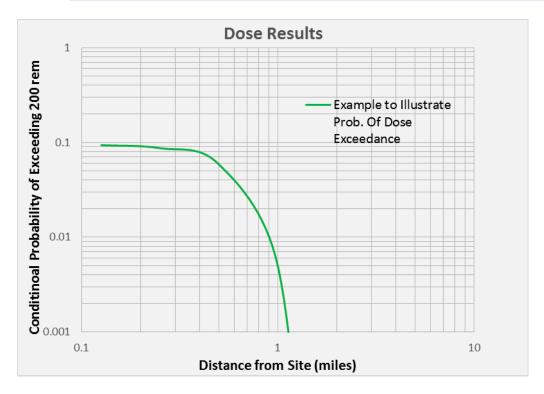
15. The paper states that specifics of the methodology for determining the probability of dose exceedance will need to be defined as part of implementation. Can more details on this topic be provided?

As discussed on page 19 of the white paper, the intent is to use the NUREG-0396 methodology for determining the probability of dose exceedance. While individual applicants may propose variations to adapt this methodology to their design, the following provides an example of calculating probability of dose exceedance using a conditional probability approach. Absolute probability could also be used, as discussed further in the response to NRC question 17.

If conditional probability is used, in equation form the probability of dose exceedance is as follows:

Consider n scenarios, with core damage frequencies  $f_1$ ,  $f_2$ , ...,  $f_n$ . Let the conditional probability of dose exceedance (given core damage) for scenario i at distance j be  $p_{ij}$ . Then summed over all scenarios, the conditional probability of dose D exceeding a given dose  $D_0$  at distance j is

$$p_j(D > D_0) = \sum_{i=1}^n f_i p_{ij} / f_i$$
